EASTERN
CONNECTICUT
ENVIRONMENTAL
REVIEW TEAM
REPORT

Brook Crossing Residential Development

East Granby, Connecticut

Environmental Review Team Report

Figure 4

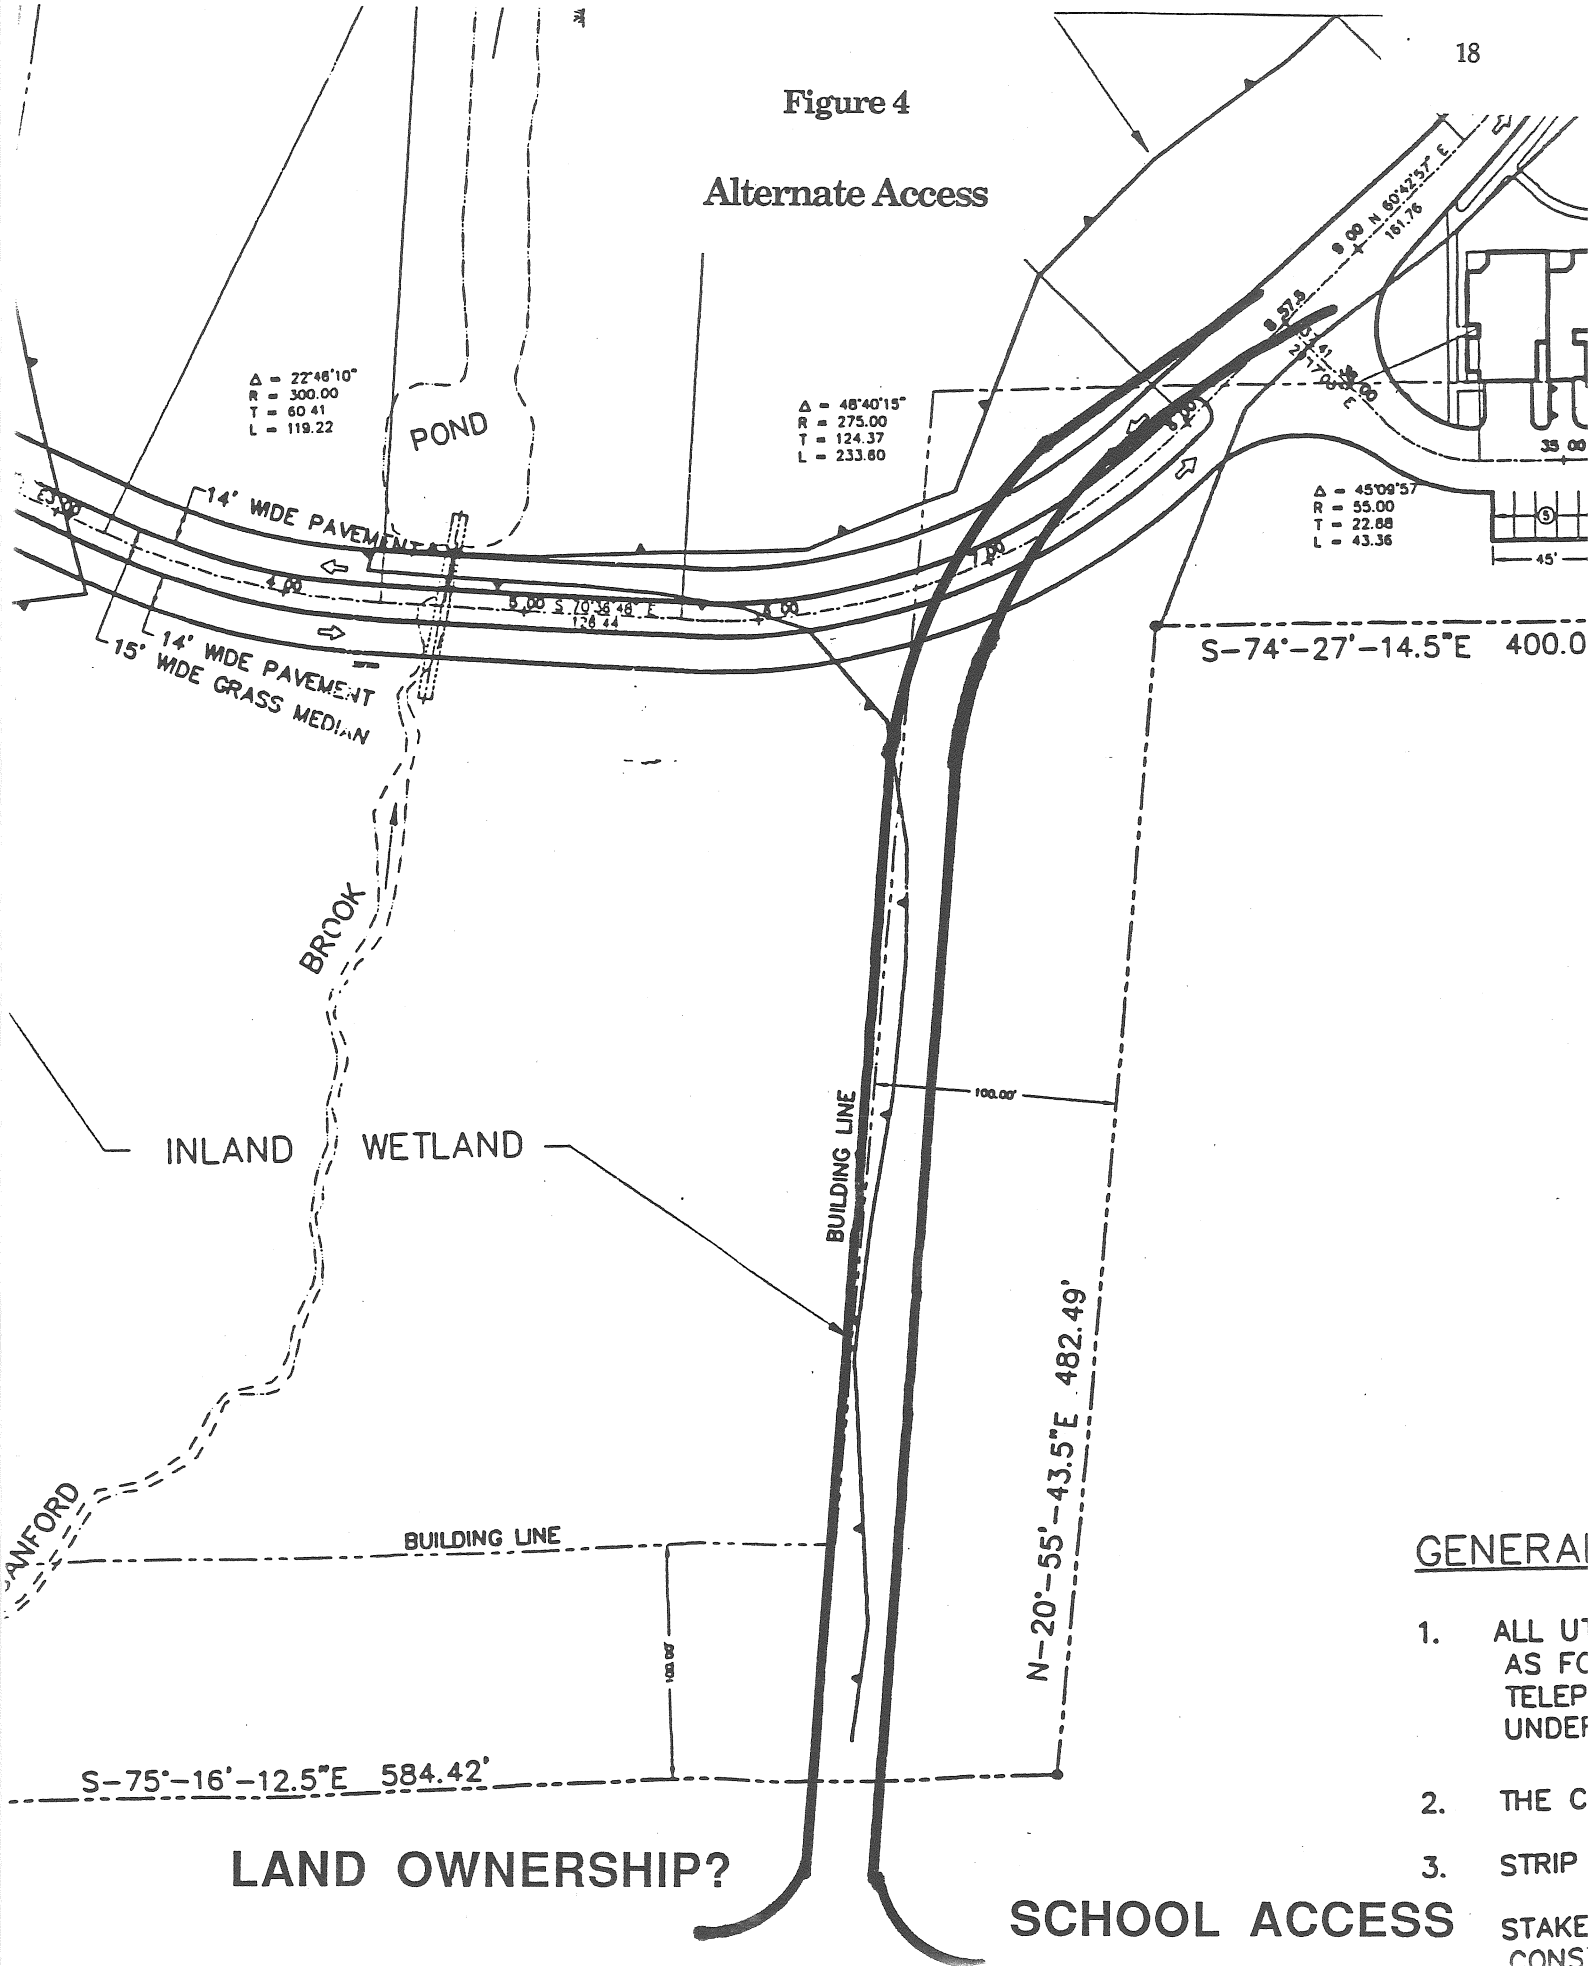
Another alternative which could be explored by the applicant would be to provide the main access from the south end via the middle/high school drive, (see Figure 4). This option may not be possible due to private land ownership along this southern boundary, however the common border between land owned by Brown and land owned by the Town of East Granby was not placed on the site plan.

1. Relocate the proposed boulevard access road. It appears that it may be feasible that access to the site can be gained via the middle/high school roadway. This would eliminate crossing Sanford Brook and wetlands and could allow for a meaningful restoration of previously degraded stream and wetland habitat.

Figure 5

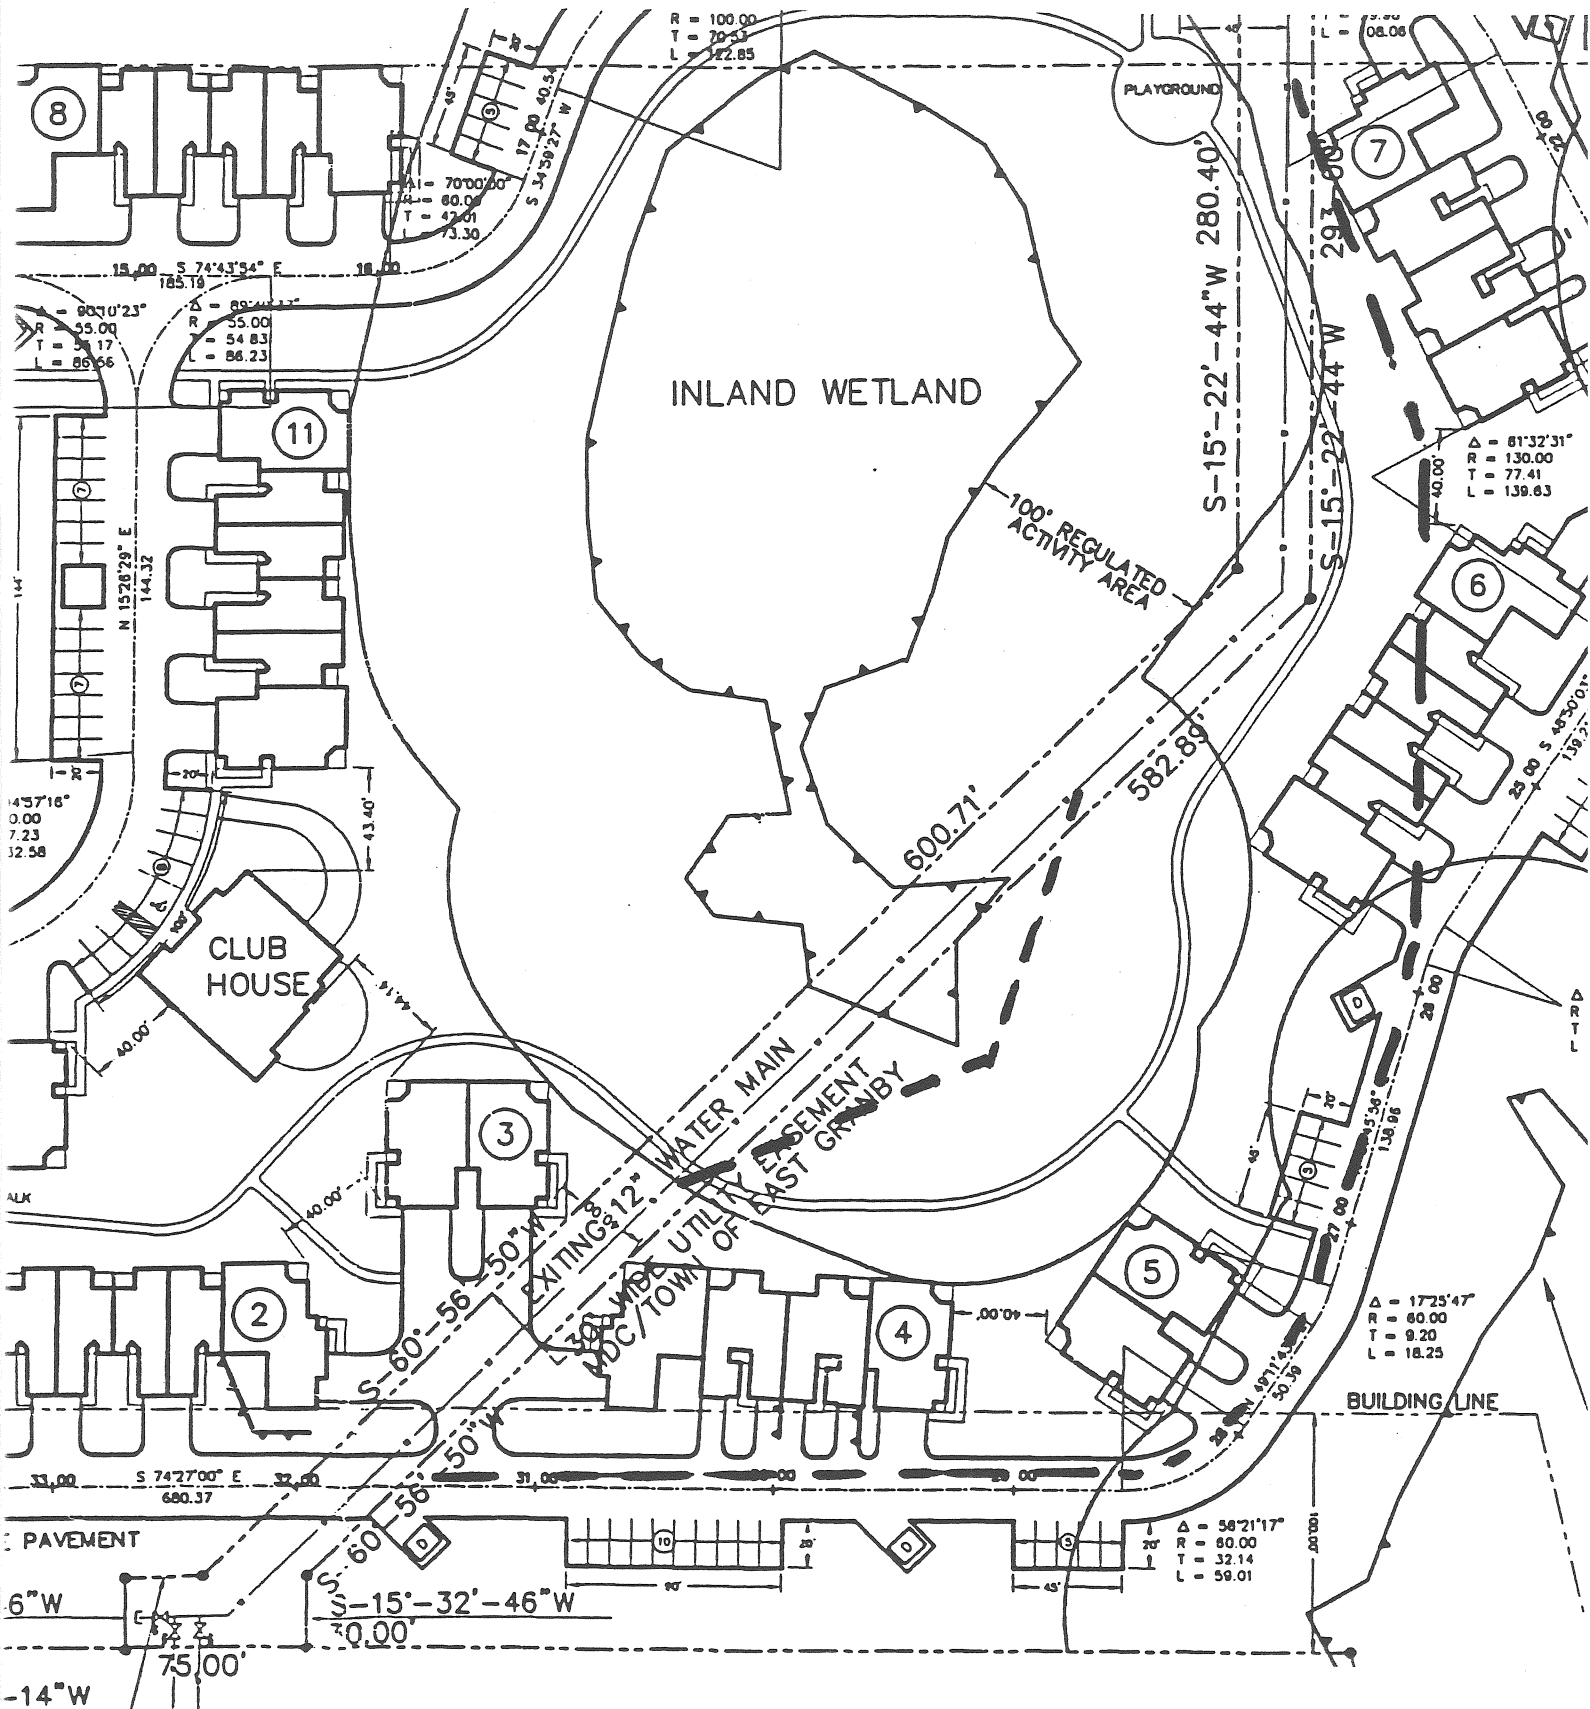
Avoiding the direct impact associated with the proposed sanitary sewer crossing of wetland "C" could be accomplished by aligning the sewer line with the 8" water line that follows the proposed road west of wetland "C" or simply taking a shorter detour around the wetland area (see Figure 5).
